Updated Focused Traffic Study for the Fox Den Dispensary

Response to Comments on the “Focused Traffic Study for the Fox Den Dispensary”

This letter serves as a response to the comments contained in “Transportation Peer Review of Proposed Cannabis Dispensary and Delivery Business at 4036 Montgomery Drive,” prepared by TJKM and dated March 25, 2019, that was included as Exhibit B of the Kiwi Preschool and Childcare appeal packet, as well as information contained the “Facts and Law in Support” section of the appeal packet.

Stopping Sight Distance Exhibit

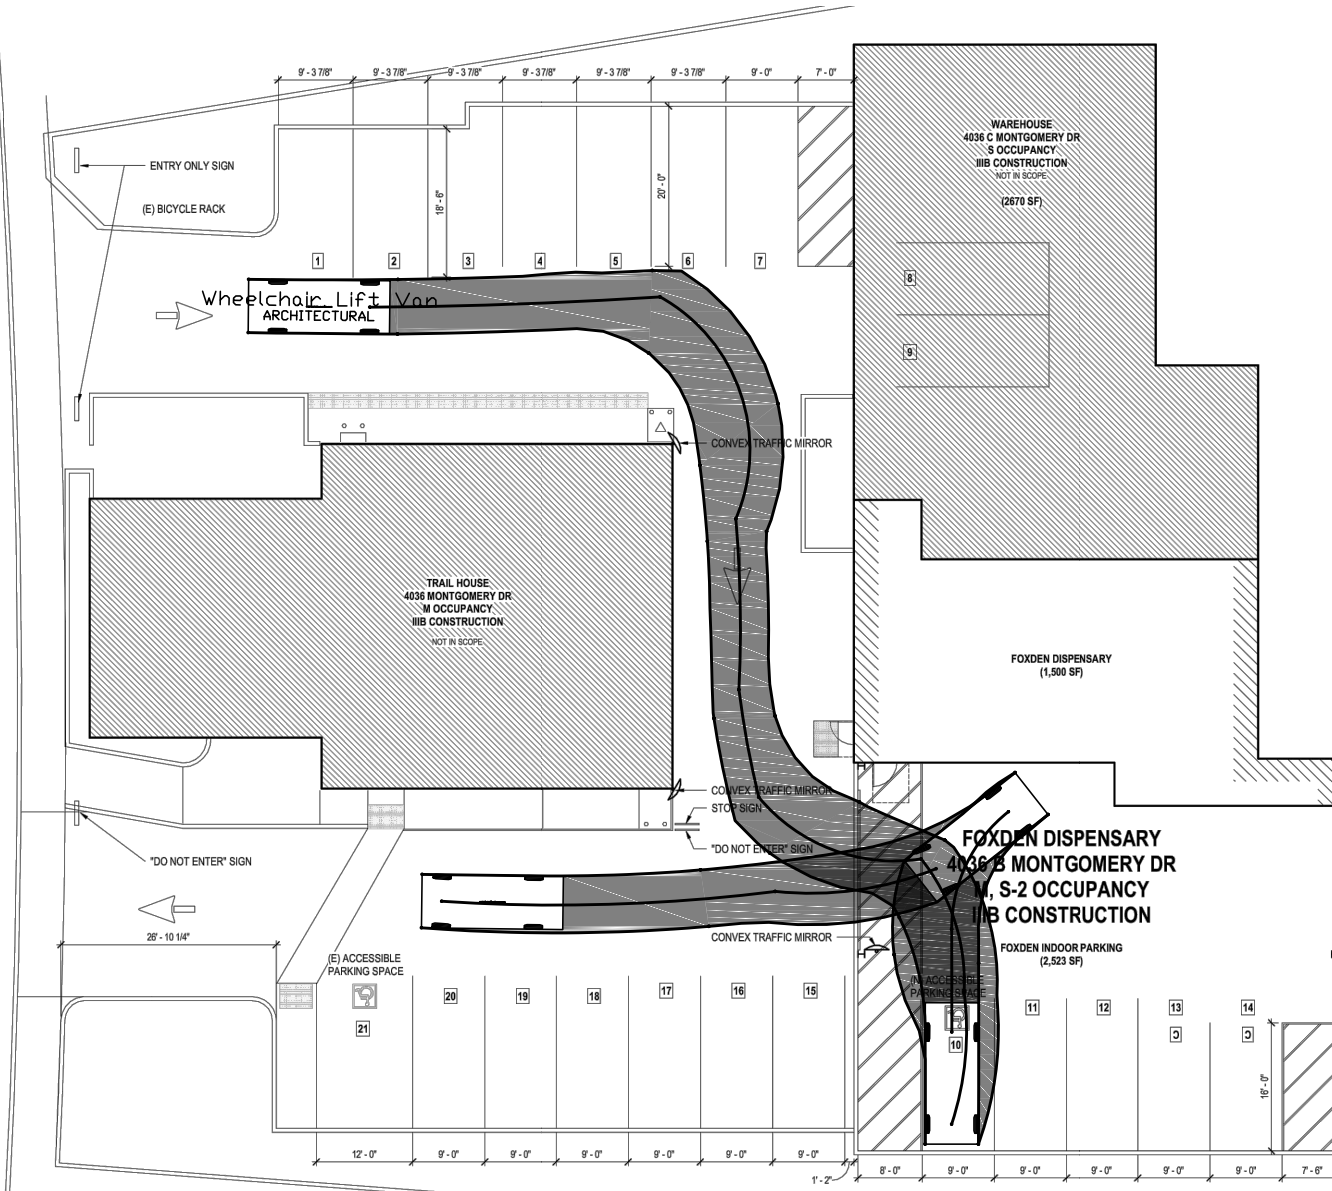
For the posted 35-mph speed limit on Montgomery Drive, the recommended stopping sight distance is 250 feet. Based on a review of field conditions, sight distance at the northeastern driveway extends approximately 300 feet to the northeast, which is more than adequate for the posted speed limit. To the southwest, sight distance can be restricted to as little as 70 feet if a vehicle is parked in the street parking space directly adjacent to the driveway, which is inadequate for the posted speed limit. In this situation, adequate sight lines can be achieved by pulling forward into the bike lane, but this type of operation is not preferred for extended periods of time. Field observations confirmed that drivers exiting the site routinely pull into the bike lane to achieve adequate sight lines. In order for

adequate stopping sight distance to be provided with the current circulation direction, the first street parking space directly southwest of the driveway would need to be removed.

As proposed, the direction of on-site circulation would be reversed so that the northeastern driveway would be used for ingress and the southwestern driveway would be used for egress. Sight lines for this modified circulation pattern were field measured at the southwestern driveway. Based on a review of field conditions, sight distance at the southwestern driveway extends approximately 250 feet to the north and further to the south, which is adequate for the posted speed limit. By reversing on-site circulation stopping sight distance would be adequate and it would not be necessary to prohibit parking for the first 20 feet of curb southwest of the driveway, as originally recommended in the January 23, 2019 traffic study. An exhibit showing the available stopping sight distance when two vehicles are parked between the driveways with both the existing and proposed access conditions is enclosed.

Finding – In its current configuration, sight distance to the southwest is inadequate when the first street parking space adjacent to the northeastern driveway is occupied, but by reversing on-site circulation adequate stopping sight distance would be available.

Recommendation – The direction of on-site circulation should be reversed from its current configuration, as shown on the site plan.

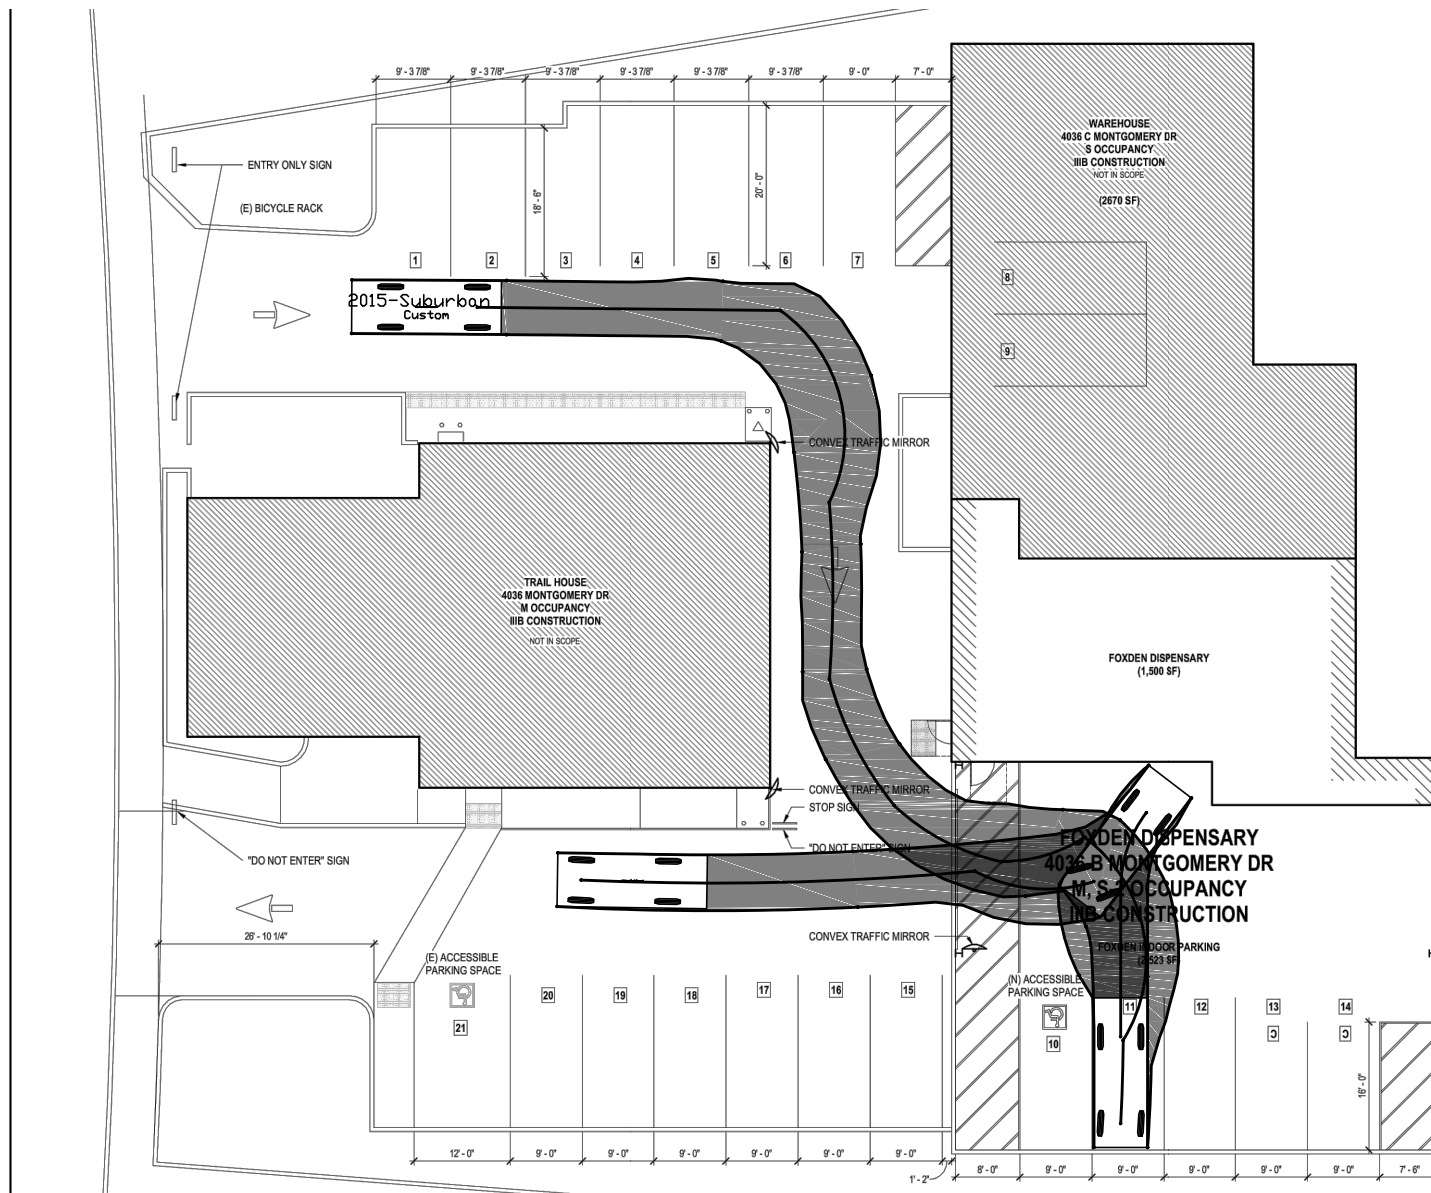
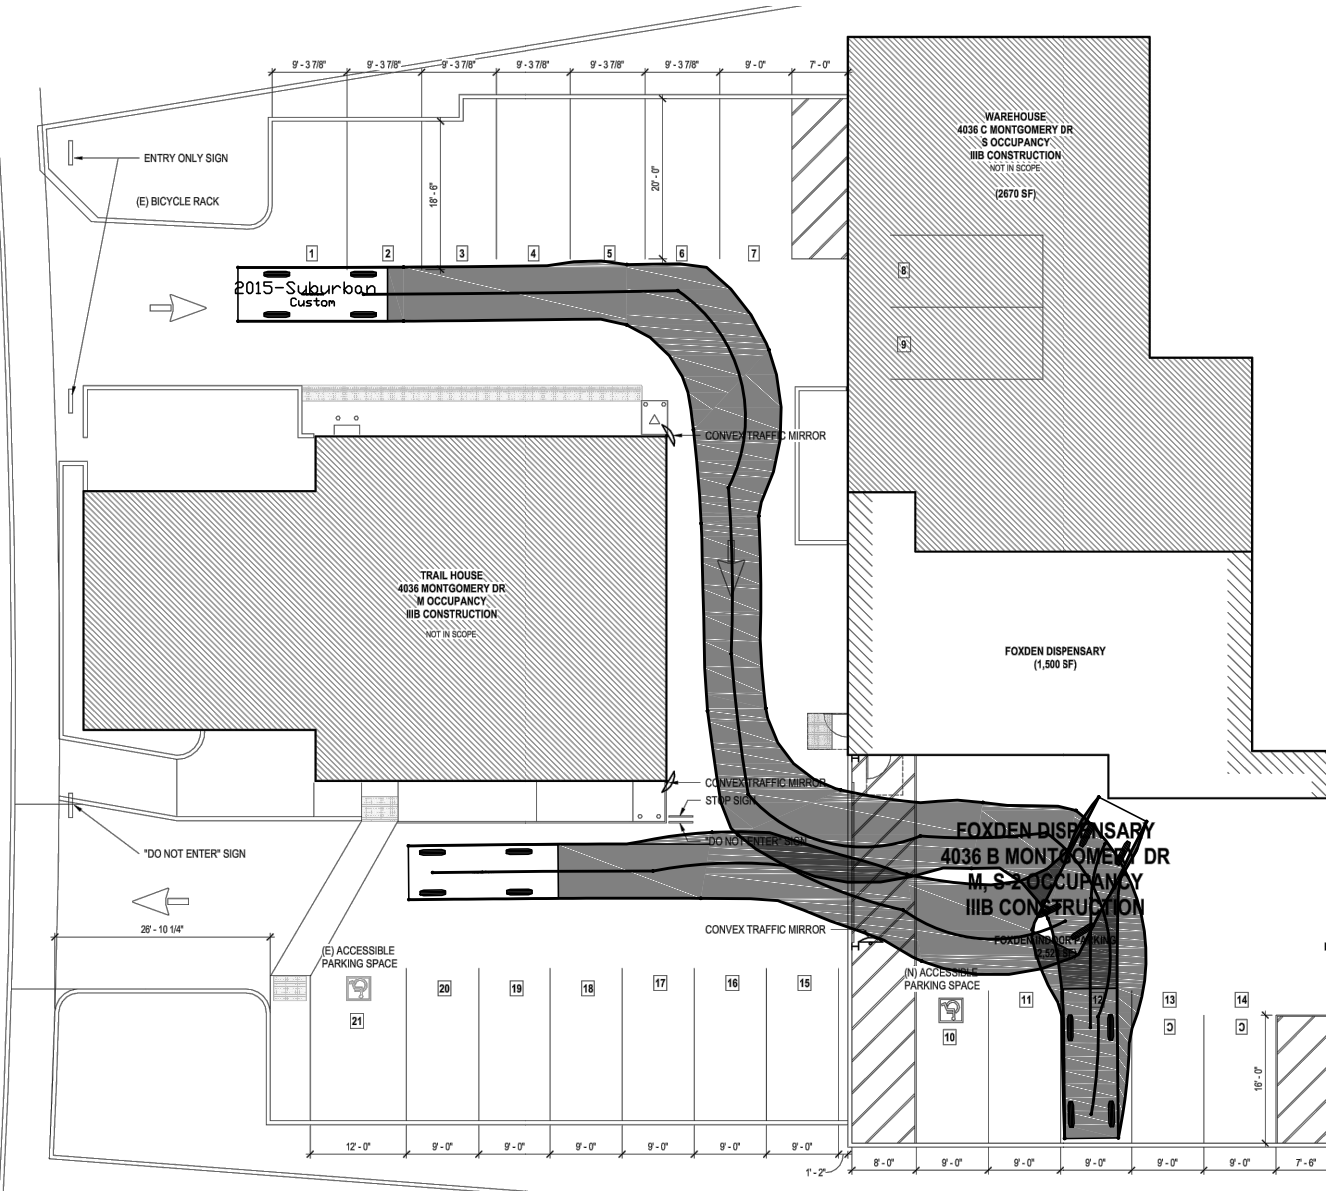
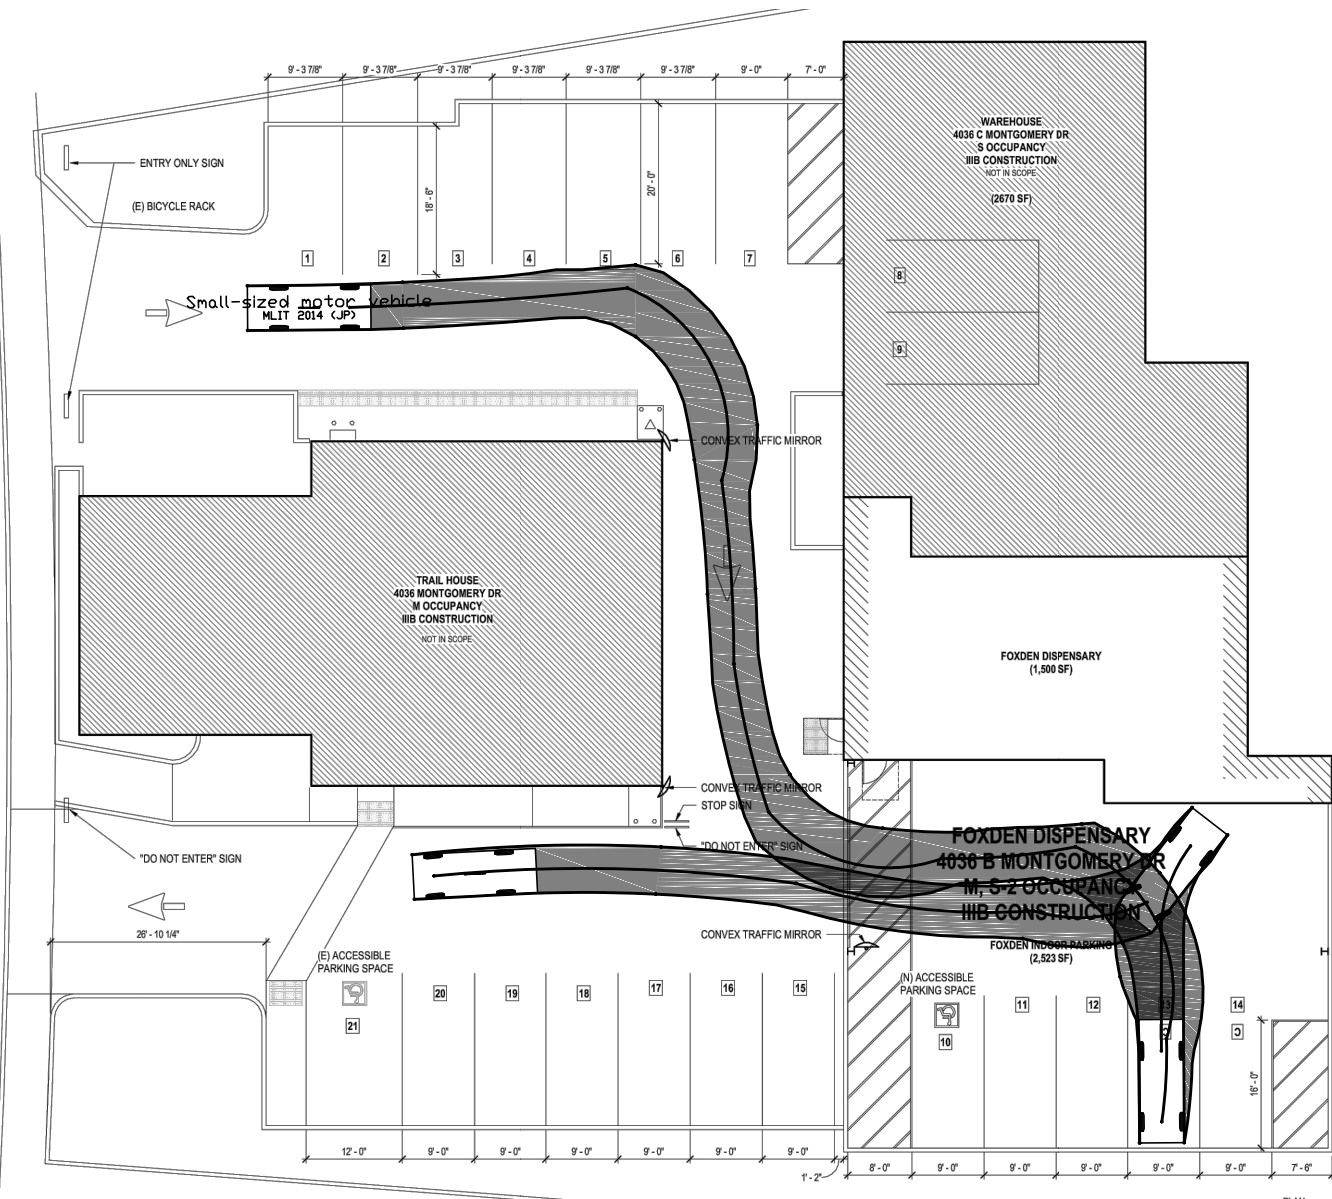
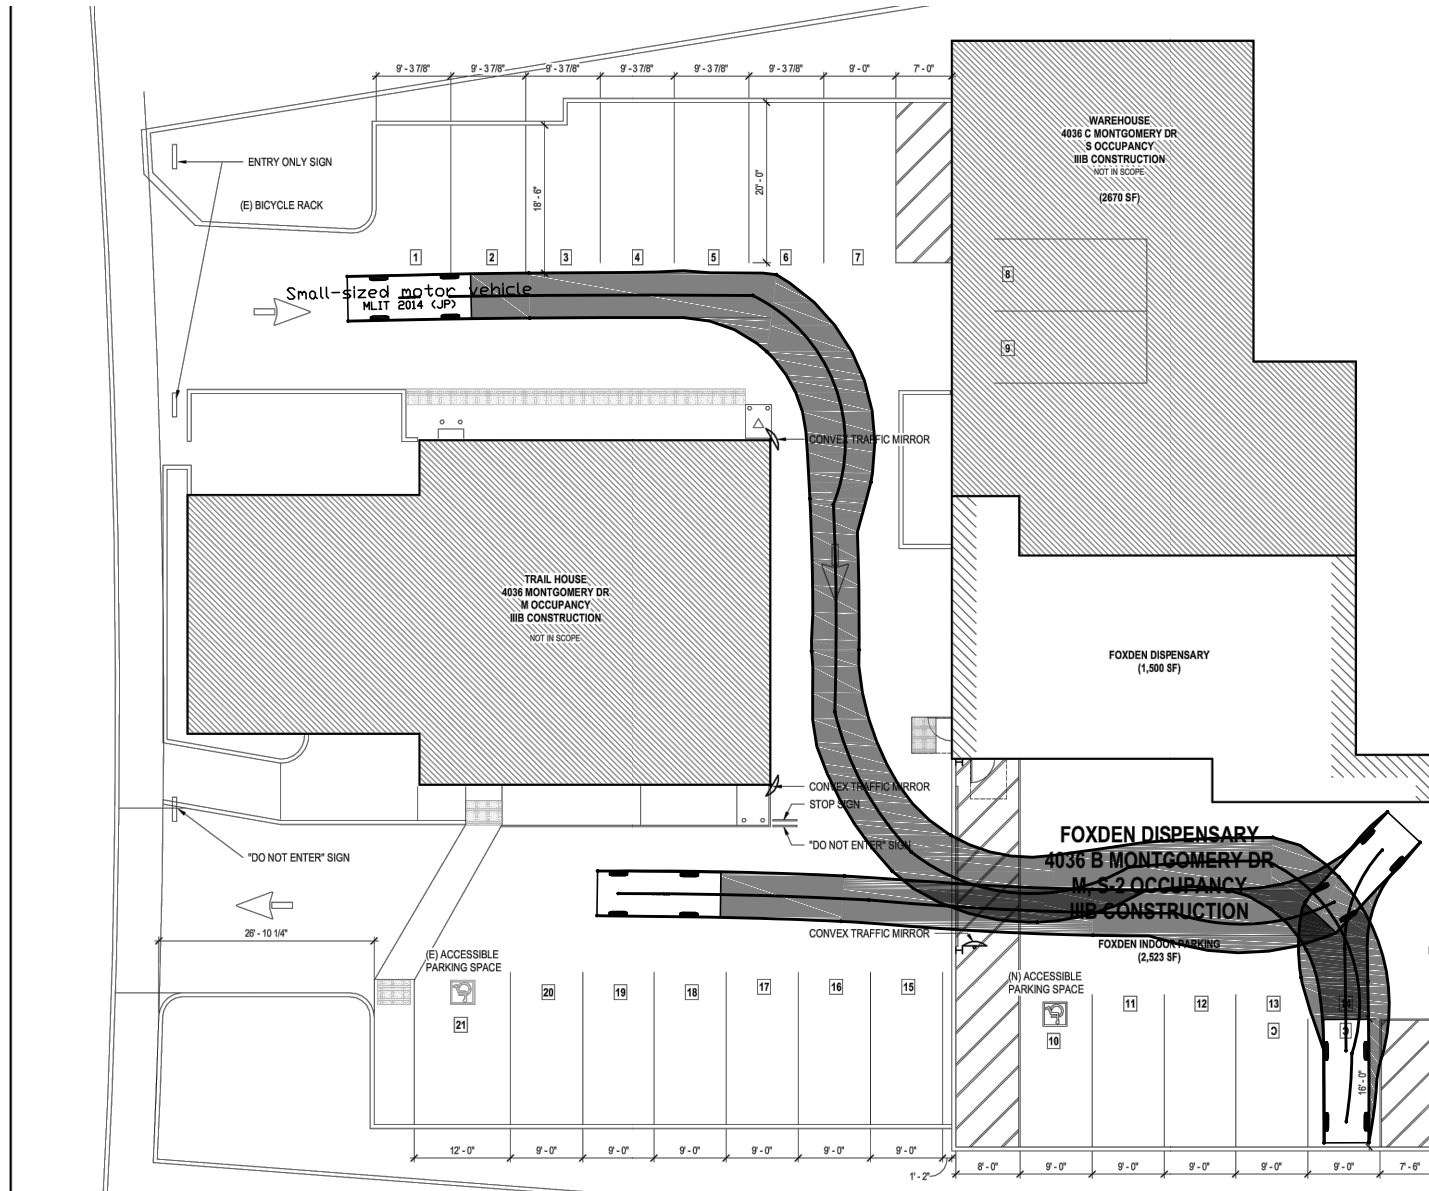
4. *The turning movement analysis provided in the Focused Traffic Study is based on typical passenger car sizes (not trucks, SUVs or delivery vehicles), and therefore does not provided a full analysis of the potential range of vehicle movements that would be required to access the seven parking spaces to be provided.*

On-site circulation was modeled in the focused traffic study for Fox Den using a standard passenger vehicle as deliveries would be made by a Toyota Prius, or another similar vehicle. To show that larger vehicles such as SUVs, trucks, or vans would be able to navigate the site as intended, circulation was also modeled for a 20-foot shuttle van. As shown in the enclosed AutoTURN exhibits, on-site circulation would operate acceptably for standard passenger vehicles as well as shuttle vans. One of the parking stalls would be signed for "15-minute" parking and would be used by the delivery vehicle when loading products between deliveries. The delivery vehicle would be off-site most of the day and loading between runs would take approximately 5 to 15 minutes, so the delivery vehicle would only occupy a parking space for a short period of time when it is on-site.
